CITY OF BOULDER
PLANNING BOARD MEETING AGENDA
DATE: August 4, 2016
TIME: 6 p.m.
PLACE: 1777 Broadway, Council Chambers

5. **PUBLIC HEARING ITEMS**
   A. AGENDA TITLE: Public hearing to consider Site Review application, LUR2015-00012, to develop the Armory site (The Armory Community), an 8.55-acre site located at 4750 Broadway (the southeast corner of Broadway and Lee Hill Dr.), with a mixed-use project with up to 200 dwelling units and 8,400 square feet of storefront retail along Broadway and two new street connections (13th Street and Zamia Avenue). The proposal includes a 23 percent parking reduction request to permit 261 parking spaces where 341 are required, but otherwise contains no other modifications to the Land Use Code.

Applicant: Bruce D. Dierking
   Property Owner: The State of Colorado

SHEET NUMBER:
A-5.08

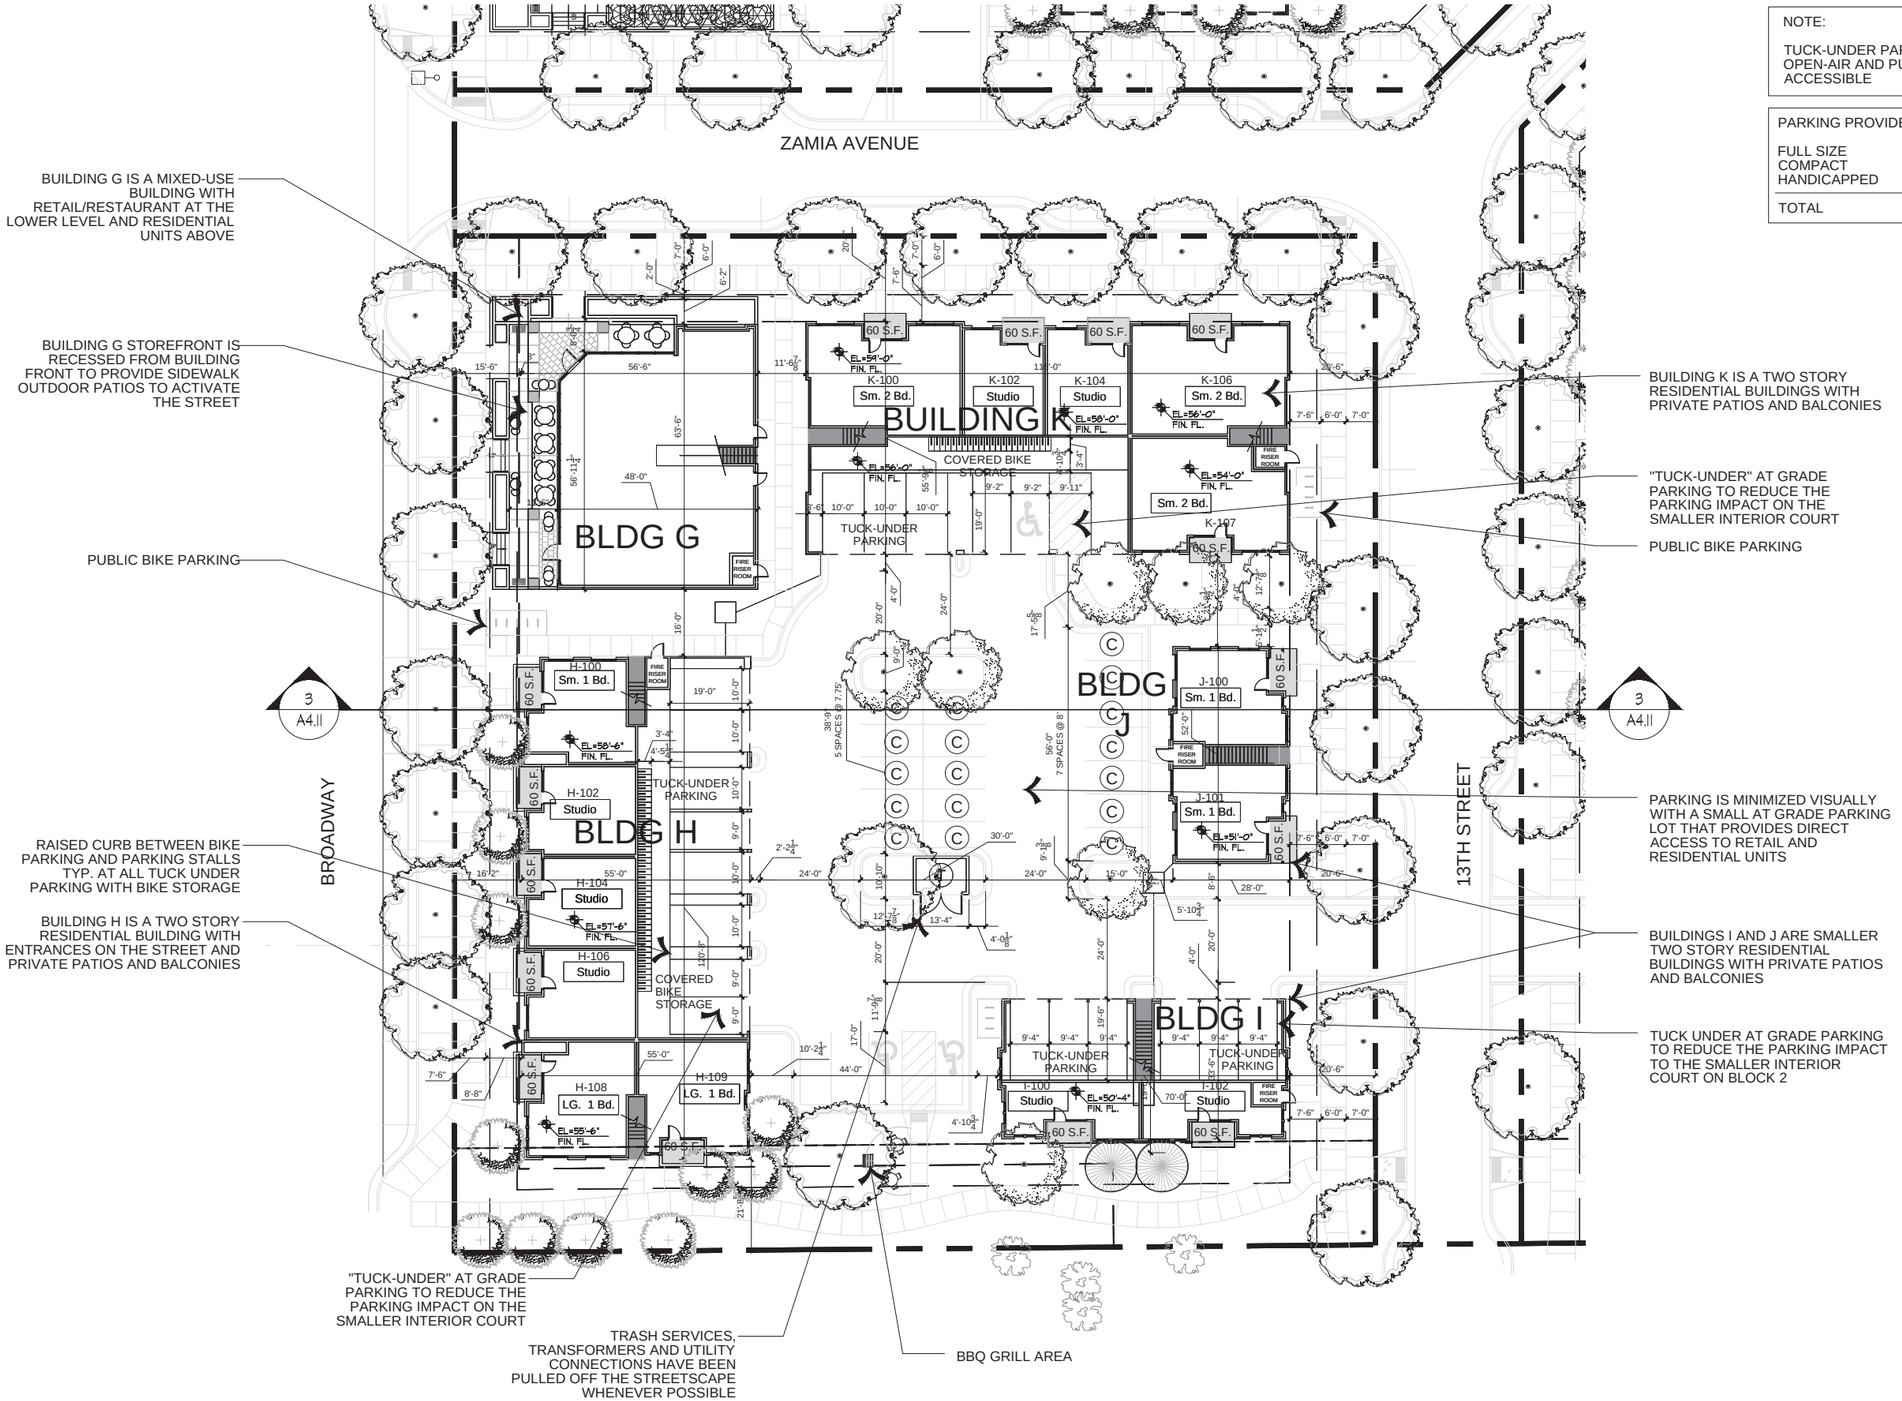
5. On Sheet A-5.08, please revise the sheet to show or correct the following: (1) revise the sheet to show the dimensions of the tuck-under parking in order to verify the dimensions and backing distances are in compliance with the Boulder Revised Code and to ensure structural columns are not encroaching within the parking spaces; (2) revise the sheet to move the curb-and-gutter in order to provide an eight-foot width for the accessible parking space at building "k"; (3) show the separation being provided between the long-term bike parking and the parking stalls in order to determine if the separation width is adequate or if bumper guards are needed in order to maintain access to the long-term term bike parking and (4) correct the discrepancy between the 24' label being shown for the backing distances and actual distance being scaled which is less than 24-feet.

A-5.13

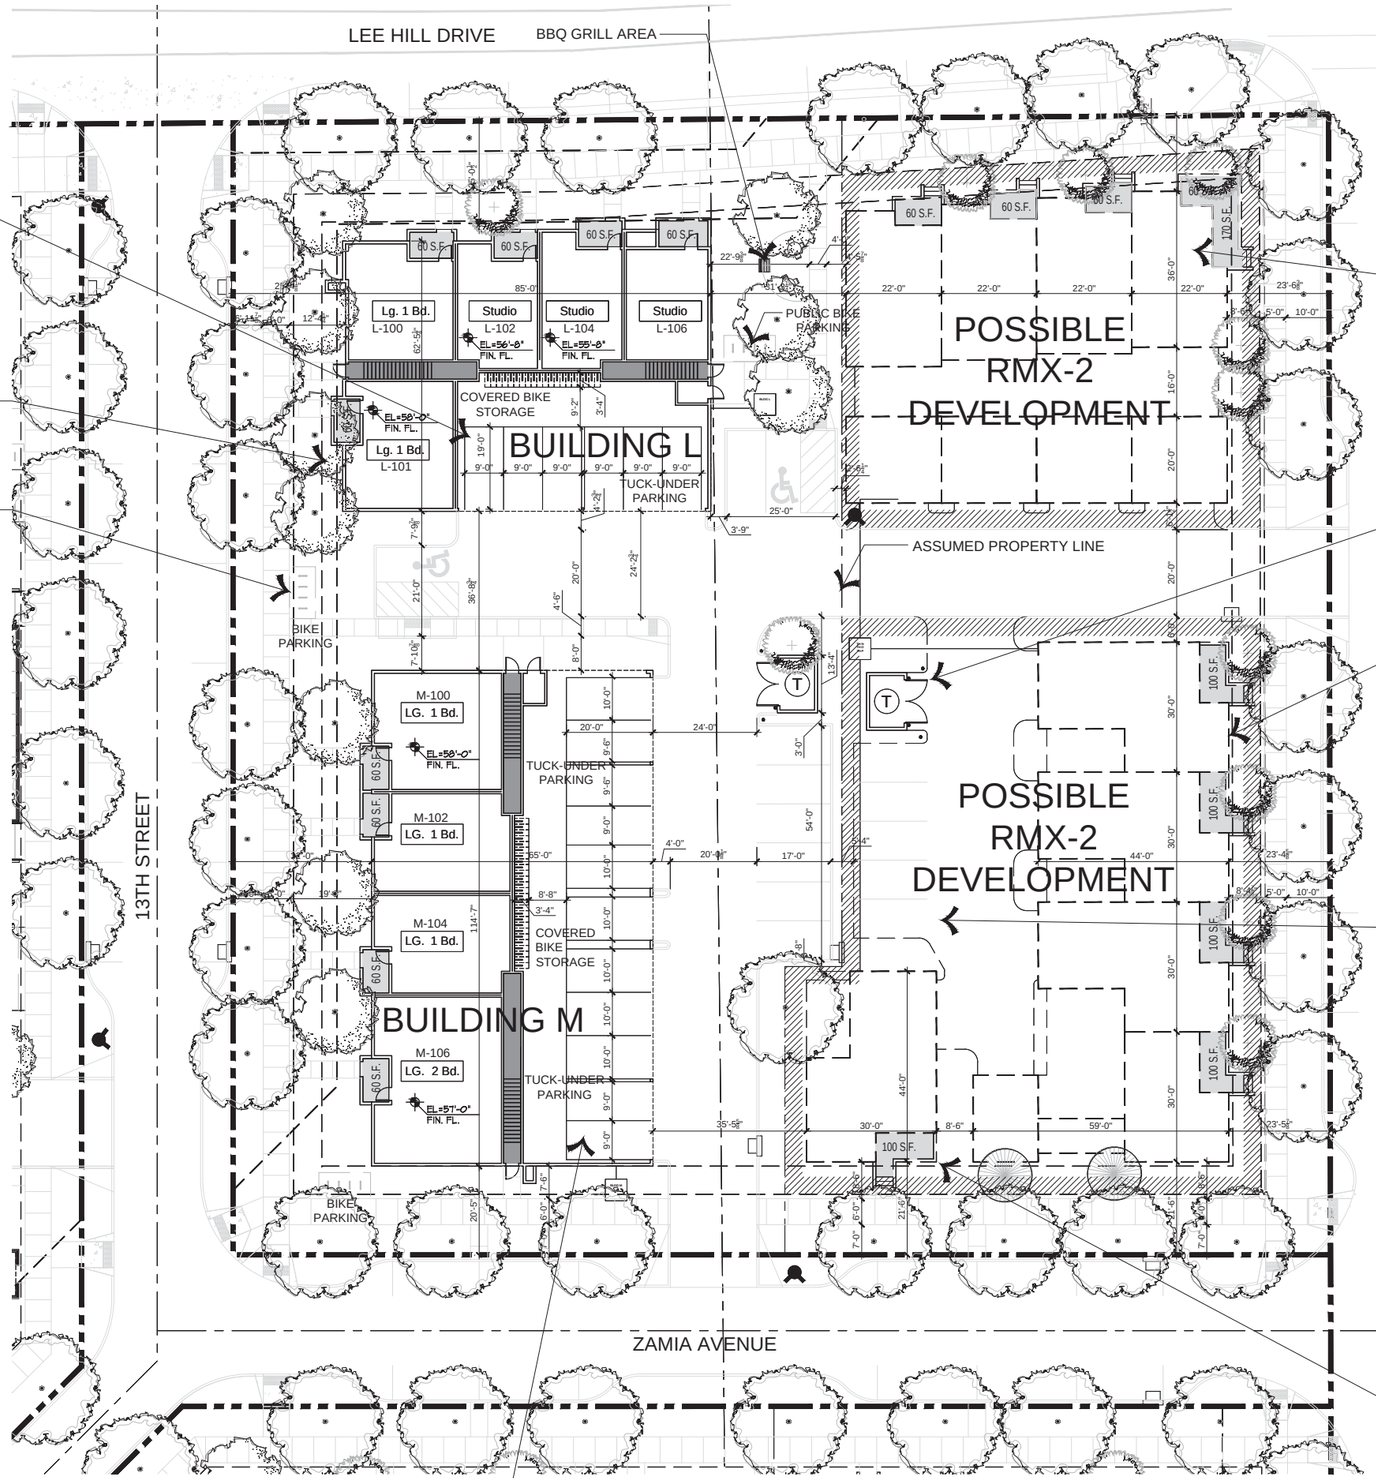
6. On Sheet A-5.13, please revise the sheet to show or correct the following: (1) the dimensions of the tuck-under parking in order to verify the dimensions are in compliance with the Boulder Revised Code and to ensure structural columns are not encroaching within the parking spaces; (2) to provide 24-feet of backing distance or each parking space; (3) to show the separation being provided between the long-term bike parking and the parking spaces in order to determine if the separation width is adequate or if bumper guards are needed to maintain access to the long-term term bike parking and (4) to demonstrate the western most parking space is accessible (entry and exit) given the adjacent uses and obstructions.

A-5.18

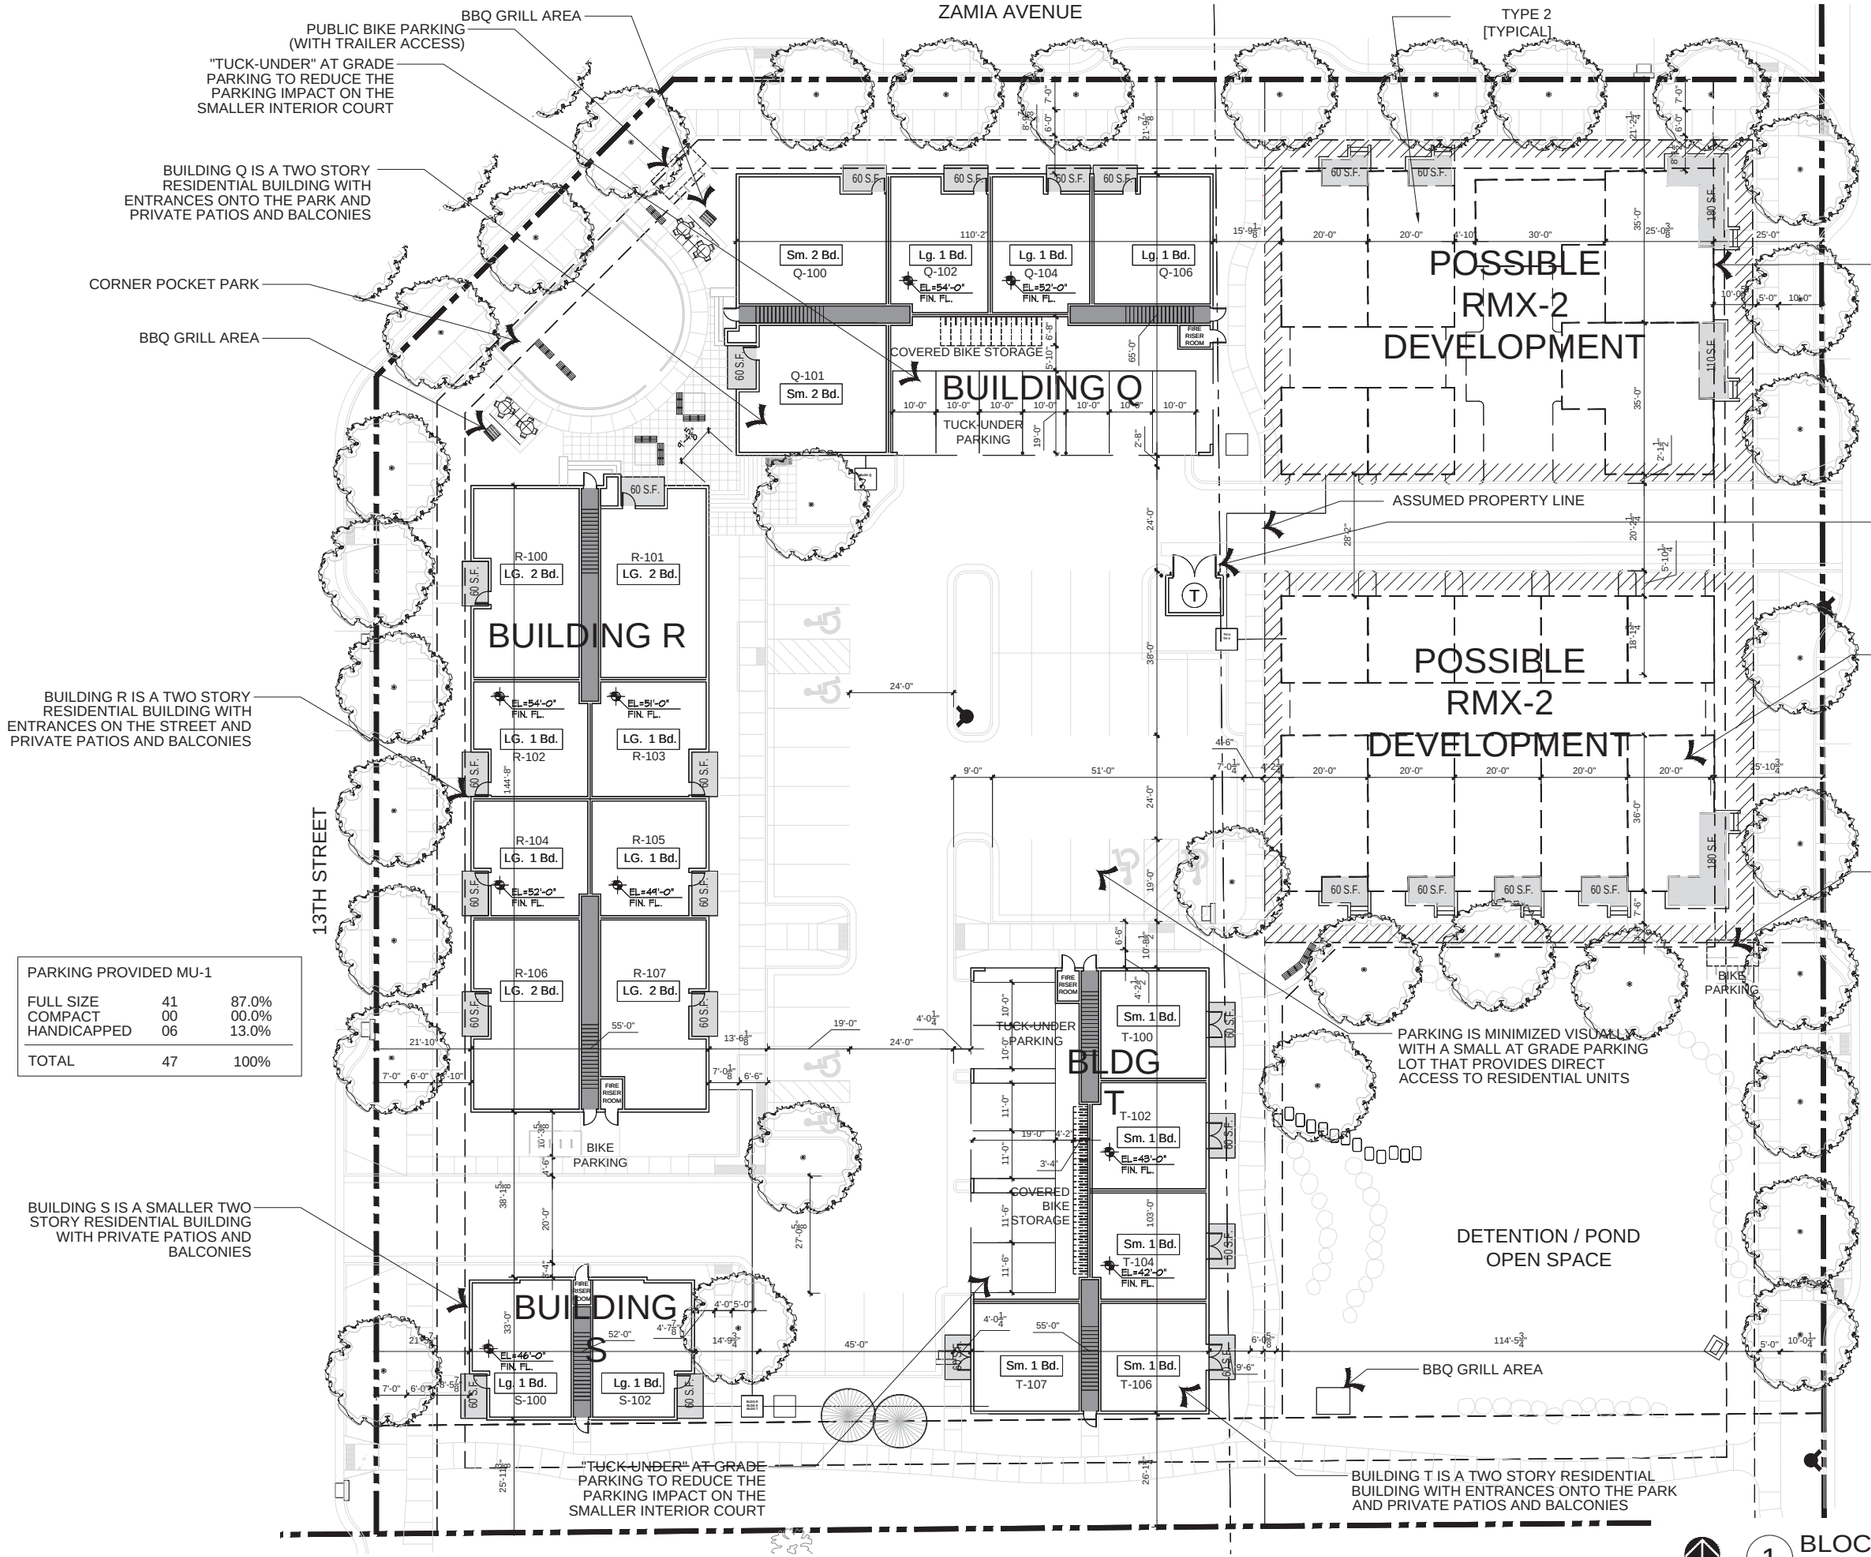
7. On Sheet A-5.18, please revise the sheet to show or correct the following: (1) the dimensions of the tuck-under parking in order to verify the dimensions are in compliance with the Boulder Revised Code and to ensure structural columns are not encroaching within the parking spaces; (2) provide 24-feet of backing distance or each parking space and (3) show the separation being provided between the long-term bike parking and the parking stalls in order to determine if the width is adequate or if bumper guards are needed to maintain access to the long-term term bike parking.

8. On Sheet A-5.18, staff does not concur with using the Type "B" long-term bike racks at building "T" because there is not enough separation between the bicycle racks and the parking spaces to provide access to the bike racks as well as maneuverability. Please revise the sheet to use another type of bike rack for the long-term bike parking.

SHEET NUMBER:
L 4.0

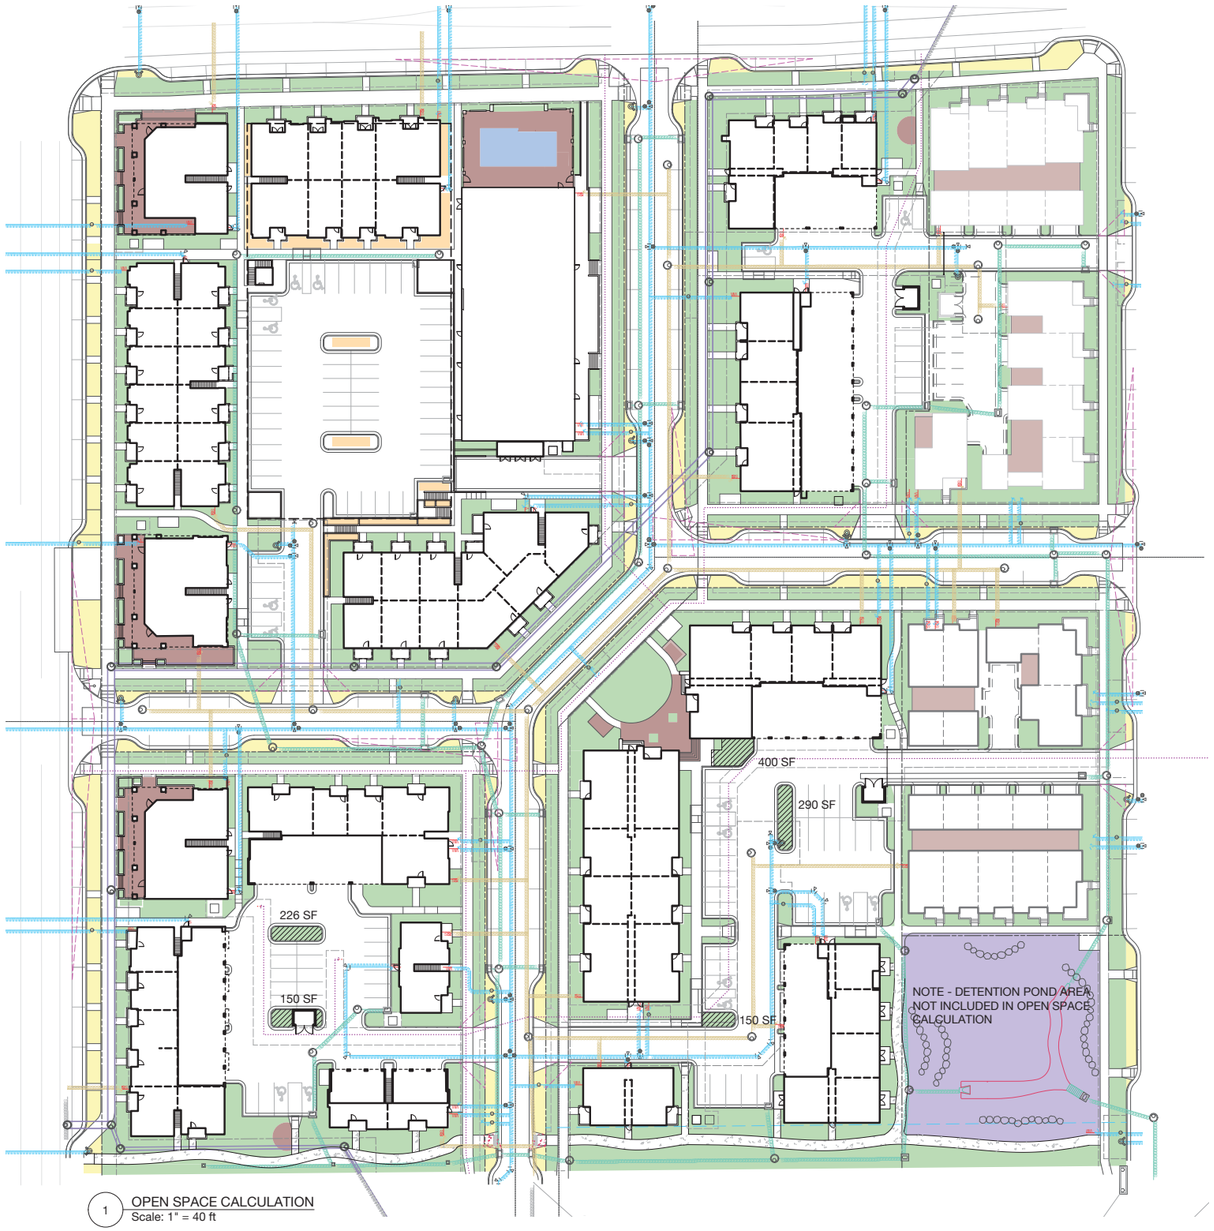
1. Per section 9-9-11(i)(7) *Land area with a slope in excess of fifteen percent unless approved as part of a site review*. Quantify areas in excess of fifteen percent in the open space diagram on sheet L4.0 with particular attention to the detention pond in the southeast corner of the project. It's not clear how this space is accessed or if the 4:1 slope with a low point more than ten feet below the adjacent high point of the sidewalk meets the intent of the open space section. Please address in the written response to comments how the pond in its entirety meets the stated purpose of open space per section 9-9-11(a) B.R.C. 1981:

5. Review the street lengths listed in table on sheet L4.0. The format is extremely helpful. Staff scales different frontages for many of the streets/blocks. Please verify the actual property lines are being used. This may not change the number of required trees due to rounding, but the frontages should match the actual property frontages regardless. While the overall site plan meets minimum requirements, there are numerous gaps in the canopy. Staff would prefer

b. Building Form
    c. Building Details (e.g. windows, shadow lines, material transitions)
    d. Building Materials
    e. Landscaping/ Open Space
11. On Sheet L4.0 it states that the detention pond at the southeast corner of the site is not included in the open space calculation; however, the guidelines indicate that the open space requirement is inclusive of the detention pond tract. Please revise the guidelines to clearly state that each lot must provide the minimum 15% required open space. Also, this section should clearly state that all open space is required to meet the open space standards found in the land use code.
